EO #1750  
JO # 999

February 2, 1976

Charles E. MacDonald, Chief  
Transportation Branch  
Division of Fuel Cycle & Material Safety  
United States Nuclear Regulatory Commission  
Washington, D.C. 20555

71-5805

D520T-6M-25

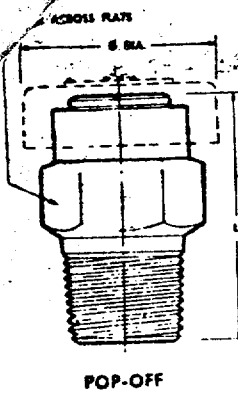
Certificate of Compliance No. 5805, Revision No. 1, page 5, 7.(a) calls for the use of a Teledyne Republic Manufacturing vent valve number 684-2-3/4-SS. While originally available this valve is no longer supplied and is not available on special order. It is requested that the herein described alternate, or equivalent, be authorized as a replacement for the discontinued vent valve.

Attached are some catalog sheets which described the currently proposed relief valve manufactured by Circle Seal Products. Model D520T-6M-25 is a most suitable replacement. It is constructed of stainless steel and has similar use and characteristics as the approved valve. It will likewise be set at 25 psig.

The Circle Seal relief valve is an exact working replacement for the original Teledyne Republic valve. All safety considerations and analysis presented in the Safety Analysis will apply for the proposed replacement relief valve.
